U. S. ATOMIC ENERGY COMMISSION  
DIVISION OF REACTOR LICENSING  
REPORT TO ADVISORY COMMITTEE ON REACTOR SAFEGUARDS  
IN THE MATTER OF  
CONSOLIDATED EDISON COMPANY OF NEW YORK, INC.  
INDIAN POINT NUCLEAR GENERATING UNIT NO. 2  
REPORT NO. 2

Note by the Director, Division of Reactor Licensing

Figure 1 - Fuel Rod Power Distribution Curve

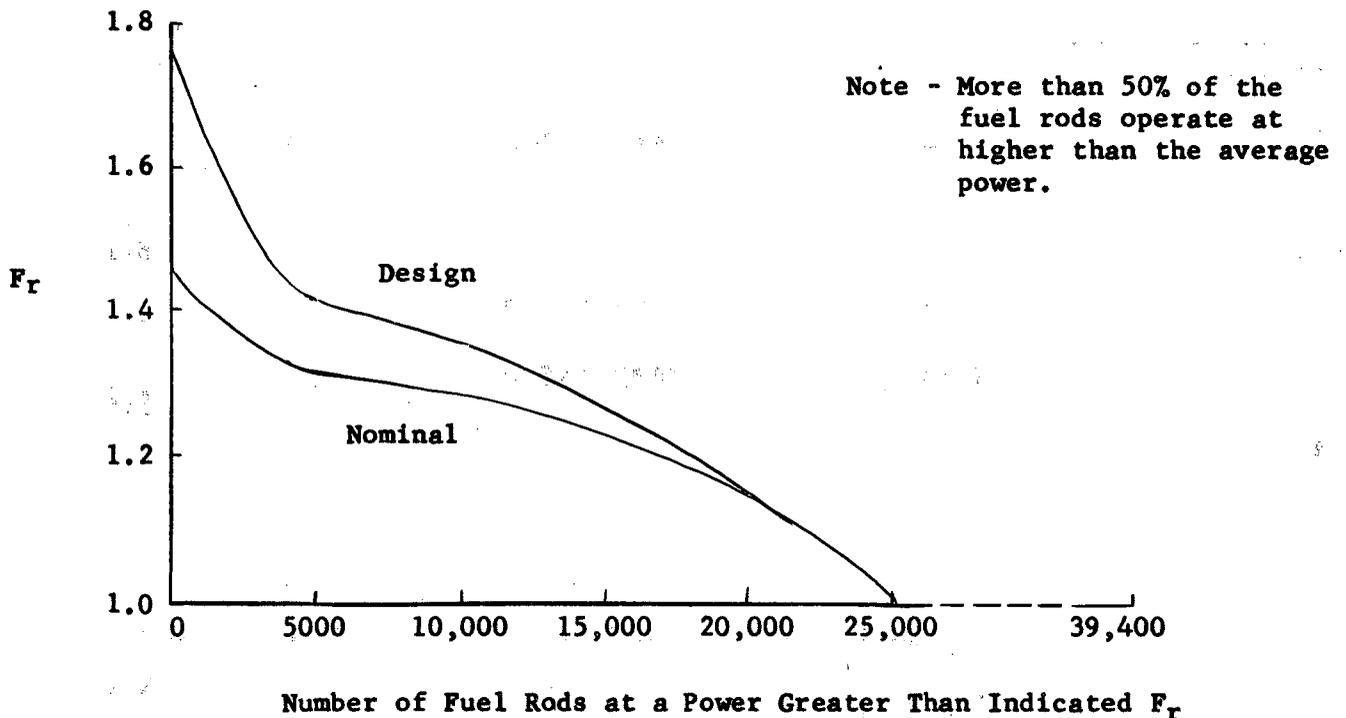
Table 1 and Figure 1 present the nuclear power peaking factors and a distribution curve showing the number of fuel rods operating at various relative power levels. The radial nuclear factor,  $F_r$ , indicates the power from a given rod with  $F_r = 1$  representing the average rod power.

We have based our evaluation of the thermal and hydraulic design of the core on the overall design condition of the core rather than on hot channel factors. In particular, we have calculated, using the statistical W-3 DNB correlation and the power distribution curve of Figure 1, the number of fuel rods that would experience DNB at the applicant's assumed overpower condition (112%). In addition, we have performed an "uncertainty" analysis of the DNB situation by arbitrarily assuming certain percentage errors in the DNB calculation. These errors, indicated by the factor  $F_{DNB}$ , can arise in several ways as we will subsequently indicate. Figure 2 presents the results of the analysis. A 10% uncertainty in the calculation of DNB results in an increase in the number of failed fuel rods from 10, at 112% power, to 40. Similarly, 33% uncertainty in the calculation results in 300 failed rods.

**Figure 2 - Number of Fuel Rods at DNB as a Function of DNB Calculation Uncertainty**

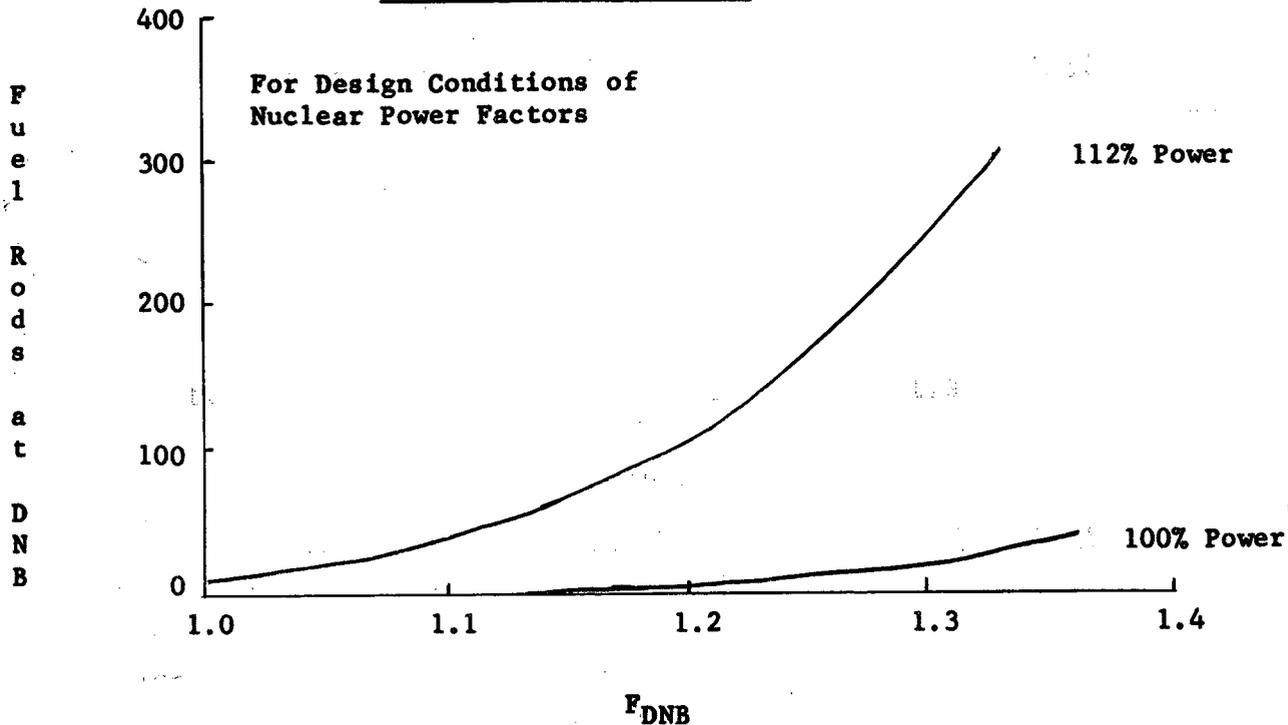
An evaluation of the safety significance of these results must be based on (1) the probability of occurrence of the combination of the design nuclear power peaking factors with the maximum expected overpower conditions, and (2) more importantly on the shape of the uncertainty curve of Figure 2. This figure shows that a rapid rise in number of failed fuel rods would not occur for the 112% overpower condition until uncertainties of 20 to 30 percent are assumed. For the 100% design power condition, on the order of 20 fuel rods would be expected to fail for these large uncertainties. Furthermore, an important safety consideration is the consequence of DNB type fuel failure on the system in general. Failure of fuel rods due to burnout in all likelihood would be local in nature, would release fission products to the primary coolant, but would not result in any massive or incipient failures in the primary system. The staff has concluded, pending verification of our calculations by the applicant, that arguments based on the preceding discussion show that the core thermal and hydraulic design does not lead to an unacceptable amount of fuel failures under assumed maximum core conditions.

Figure 3 - Center Melting as a Function of Calculational Uncertainty

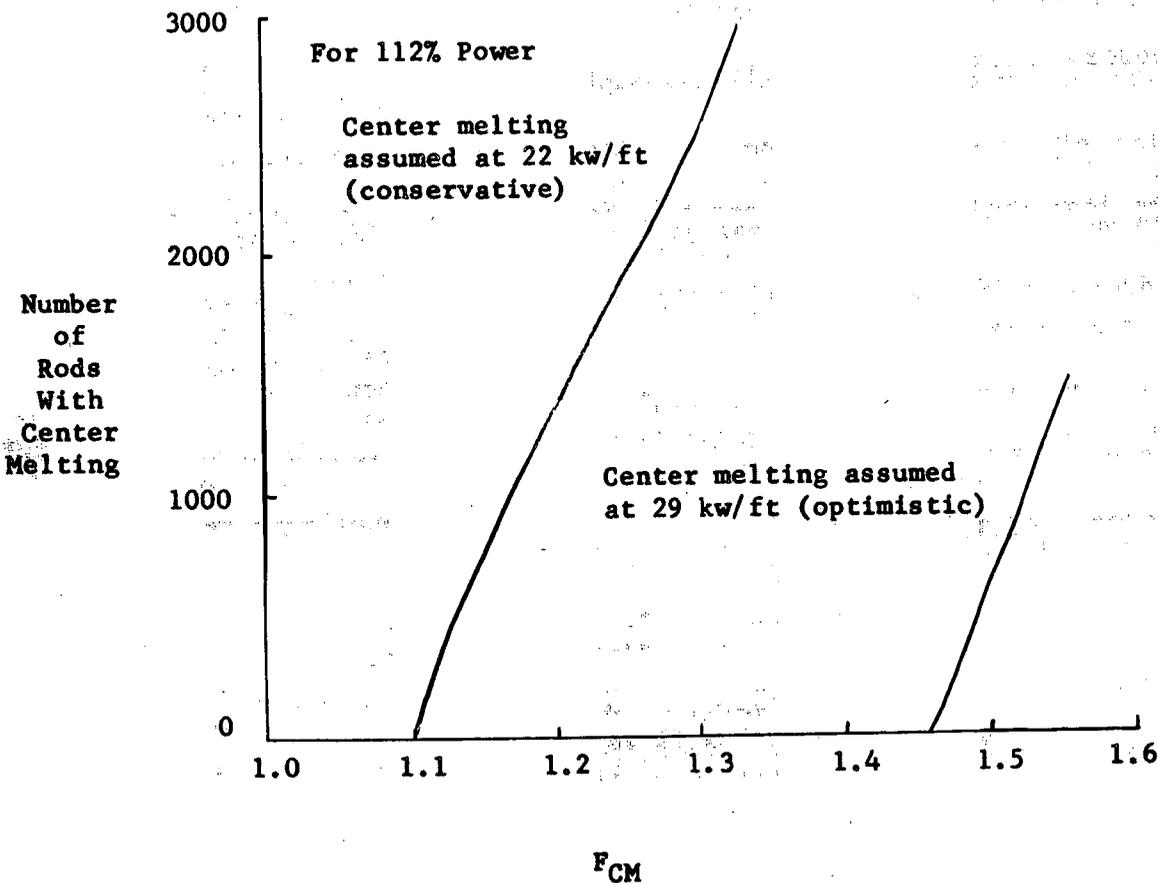
We have also calculated, for the same considerations discussed in the DNB analysis, the number of fuel rods that would have center melting at 112% power with various assumed uncertainty factors in the calculation. Results, presented in Figure 3 for the 112% power condition, show a relatively rapid rise in the number of fuel rods which would experience center melting as the uncertainty factor approaches 30% using the conservative experimental data. The main contribution to the  $F_{CM}$  factor would be from uncertainties in the nuclear power factor (almost directly proportional). For the 100% design power condition the value of  $F_{CM}$  in Figure 3 should be increased by 12% to obtain similar center melting conditions. These results do not indicate the fraction of a given fuel rod with center melting. In general, melting would be limited to the central region of the rod with the vertical length of melting (perhaps

1 to 3 feet for some of the rods) dependent on the axial power distribution and the magnitude of the  $F_{CM}$  factor. Considering the conservatism of the data which has to be used to show substantial melting, and the unlikelihood of large errors in power factors, we have concluded that the probability of substantial center fuel melting is small and acceptable.

Figure 4a - Containment Pressure Transients

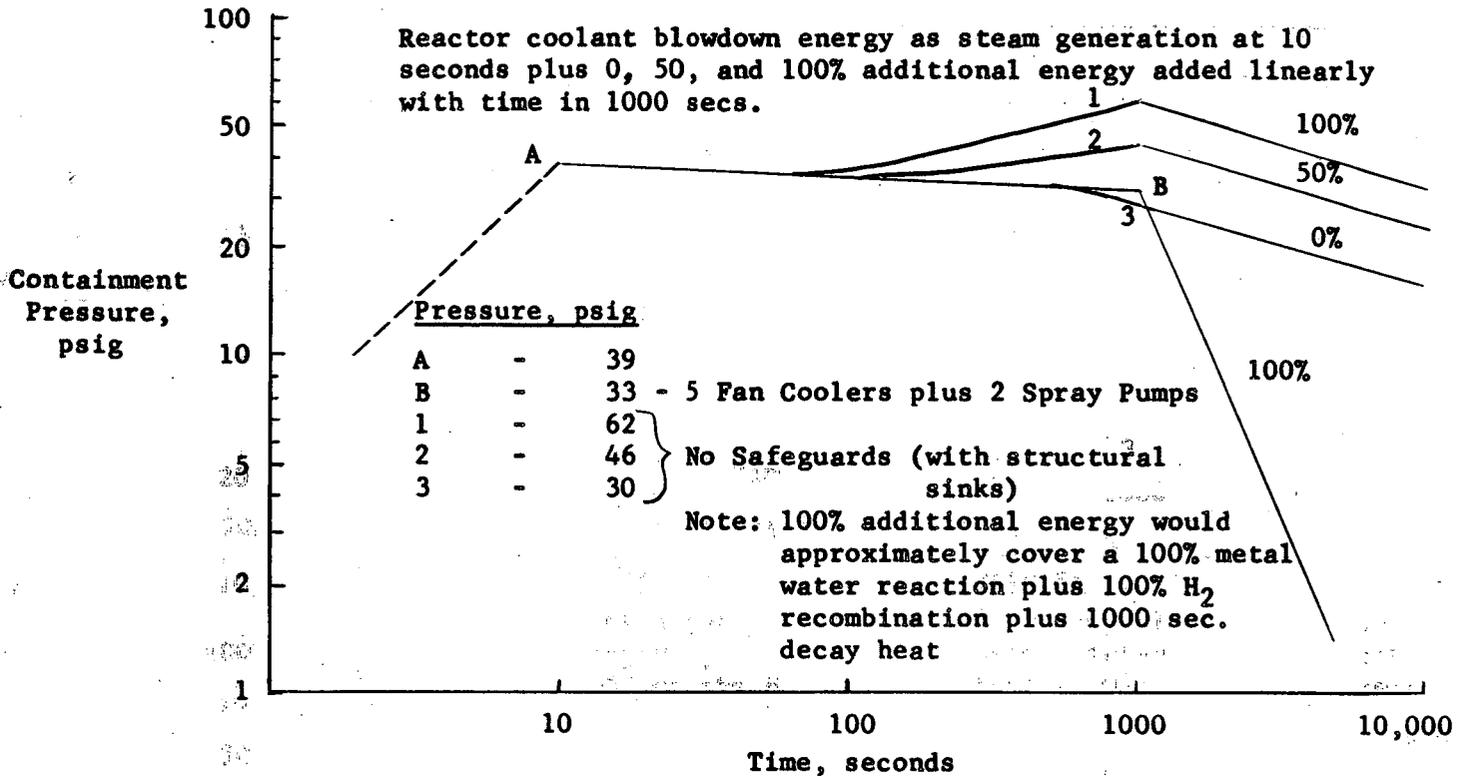
Figures 4a and 4b are compilations of results given by the applicant as part of answer No. 4 of Supplement 1. Although the maximum pressure shown in Figure 4a appears to be too low by approximately 10-15 psi, we believe a figure such as Figure 4a can be used to "bracket" the worst (no safeguards) and best (all safeguards) values of containment pressure. Figure 4b shows the situation for sudden hydrogen burning of 65% of the hydrogen available from a 100% metal-water reaction with no other energy addition (for computer purposes the applicant assumes a 10 second burning period instead of a step addition of energy).

Figure 4b - Containment Pressure Transients

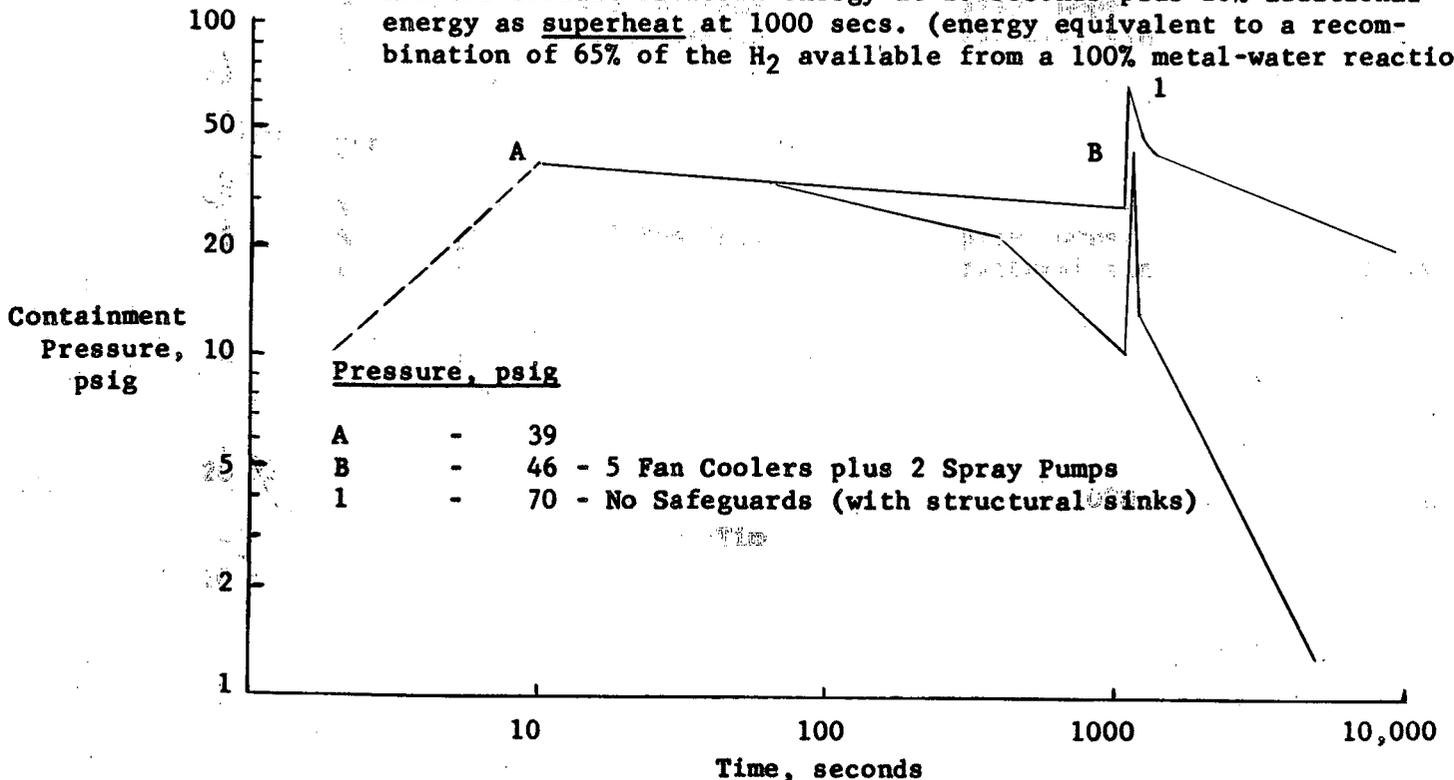
Reactor coolant blowdown energy at 10 seconds plus 20% additional energy as superheat at 1000 secs. (energy equivalent to a recombination of 65% of the H<sub>2</sub> available from a 100% metal-water reaction)
